Royal College Street

Project	Job No.	Doc No.	Date
Eagle Mews, 146-150 Royal College Street	1028337	TN01_P01	13/08/2021
Subject	Prepared by		
Cundall's response to LBC Comments	Valeria Riso

This note summarises the comments received from LB Camden within their interim comments for 150 Royal College Street received on 13th August 2021 with regard to transportation aspects of the proposal (registered application under 2021/2472/P) and provides a response to each comment (in **blue&bold**).

Cundall's response: Please note revised tracking drawing TC-005-P04 (extract included below), indicating a 3-point turn manoeuvre performed on-site by a 3.5t panel van vehicle.

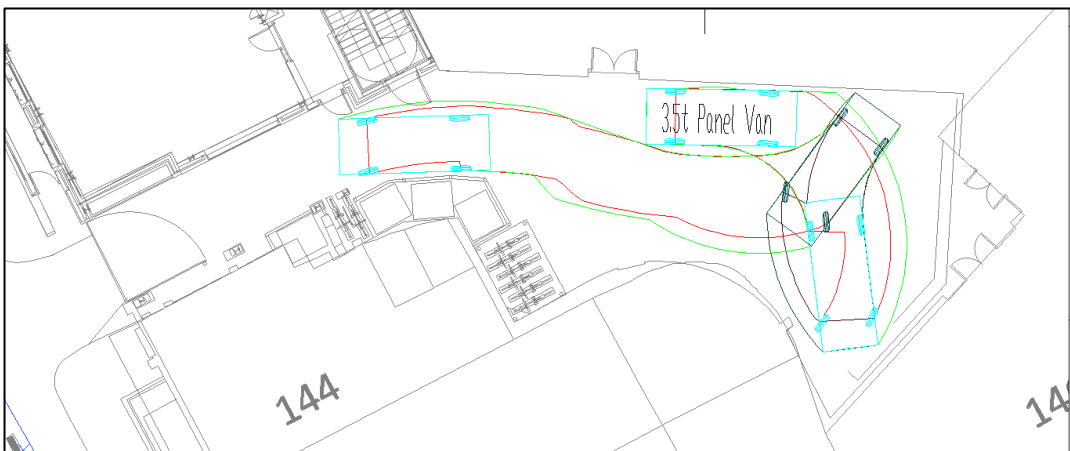
A swept path drawing has been submitted for the on-site turning manoeuvre, showing a 7-point turn. (The applicant describes it as a 6-point turn. This is a semantic point, but I consider a manoeuvre with: 1 reverse to be a 3-point turn, 2 reverses to be a 5-point turn, and 3 reverses to be a 7-point turn). The tracking is based on a van of width 1.986m. This is not a conservative estimate of the upper limit given that the width of a Ford Transit with folded back mirrors is 2.112m. The tracking over-sails a footpath and would clash with an open door. In mitigation of the last two points, the applicant states that the footpath is the same level at the access route (but made of a different material). Also, the door is used for maintenance is anticipated to always remain closed. The second point raises a question as to where the main entrance to the new building would be as the only other entrance door at ground level appears to have a width of only 800mm.

Taking all the preceding factors into account, I consider there is a real risk that drivers would not attempt the turning manoeuvre, rather they would reverse out of the site. This would have inherent dangers and I cannot support this proposal.
